CERTIFICATE OF APPROPRIATENESS

Property: 301 E. 10th Street, Tracts 13 & 14, Block 219, Houston Heights Subdivision. The property includes a historic 1,748 square foot, one-story wood frame single-family residence and attached garage situated on a 8,200 square foot (82' x 100') corner lot.

Proposal: Alteration – Construct an 881.5 square foot second-story addition over the existing new garage.

Recommendation: Denial - does not satisfy criteria 1, 4, 8, 9

EAST SIDE ELEVATION

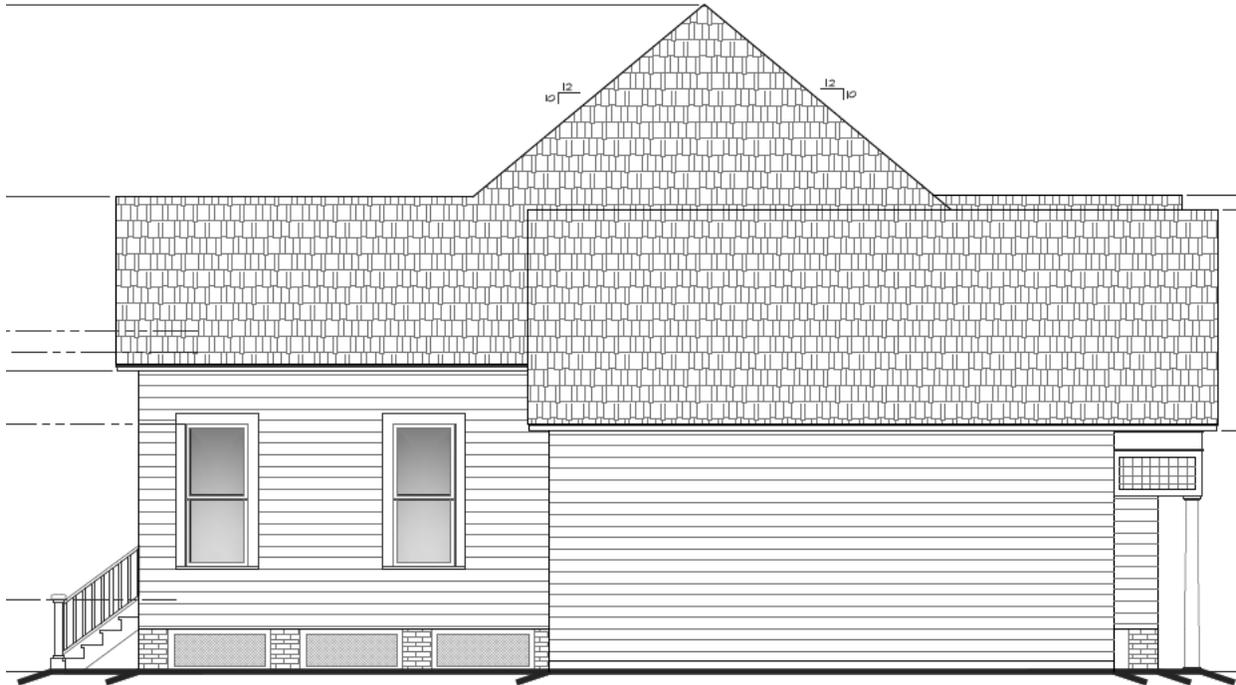
<i>Because of the corner condition of this lot, the alterations to the unique pyramid roof are clearly visible. Constructing a second-story addition on top the previously constructed garage structure and connecting to the proposed second-story addition by extruding the existing roof towards the rear does not retain the historic character of the property.</i> |

<i>The unique pyramid shaped roof of the original structure is a distinguishing characteristic of this building. Constructing a second-story addition on top the previously constructed garage structure and connecting to the proposed second-story addition by extruding the existing roof towards the rear does not preserve this distinguishing characteristic.</i> |

<i>Constructing a second-story addition on top the previously constructed garage structure and connecting to the proposed second-story addition by extruding the existing roof towards the rear will impair the essential form and integrity of the original unique pyramid roof form. Additionally, the walls will have to be reframed in order to support the added load of a second-story. This will not only lead to the removal of interior shiplap, but to the removal of the studs and portions of exterior siding, and roofing material.</i> |
